Injection region BLMs – IP2 and IP8 Suggestion of changes – version 2

- Re-distribution of quadrupole BLMs to dipole interconnects in the injection regions
- Layout and threshold changes to allow for higher injection losses and to replace SEM
 - Monitors and filters (new LICs)
 - Channels for possible injection timing blind-out
- Scheduling

Problem with low sensitivity monitors (LIC, IC+filter)

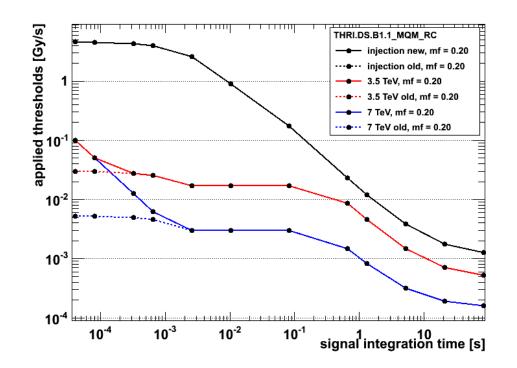
- On some cold elements the noise level is above the threshold level
- General guideline: use IC+filter on blind-able monitors
 - If we switch on the blinding, we can take away the filter, adapt the thresholds and reduce the problem of sensitivity at high energy.
